15 January 2014 (Rev. 16 January 2014)

RE: Press Hotel – 119 Exchange St., Portland, Maine

Following are responses to comments contained within the review from FirePro dated December 9th, 2013:

SK-M01

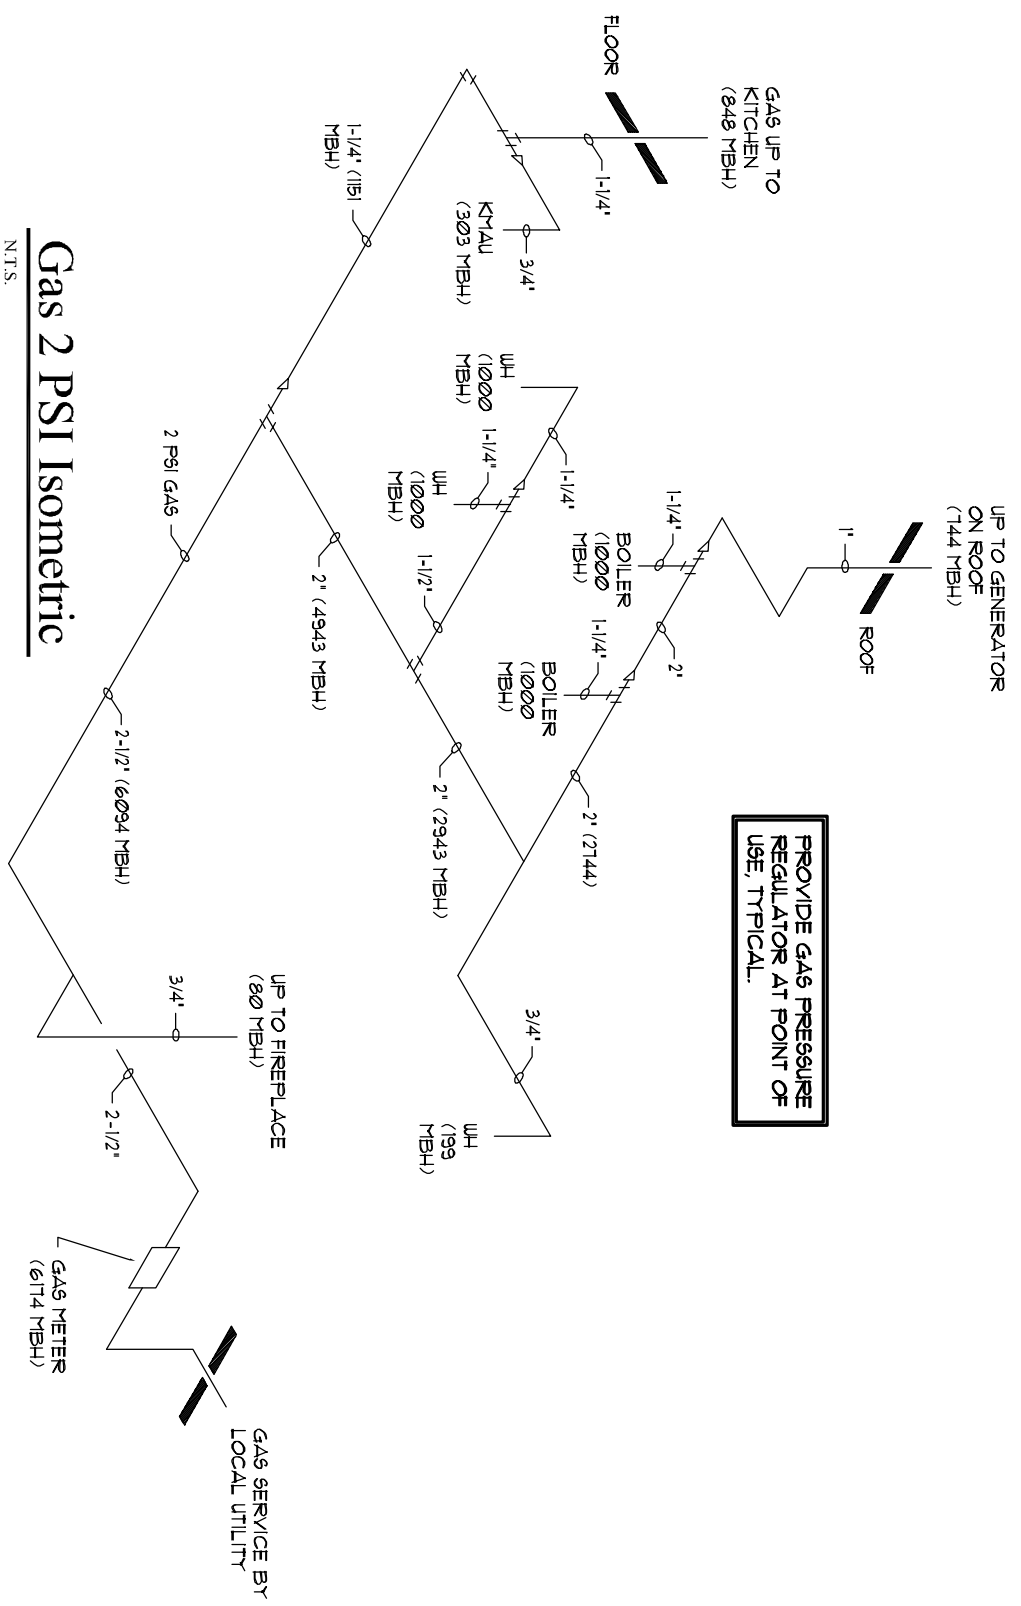
5. *Provide a clear legend of all devices shown on the Life Safety drawings. Response: See revised LS1.1 and LS1.2 included under separate cover.*
6. *Provide details of the operation, fuel source, and fuel fill routing for the emergency power generator for the building. Response: See attached below sketch SK-M01 for the means and route of the gas piping serving the emergency generator. Also note revised drawing sheet M0.10 for integration of riser into set.*
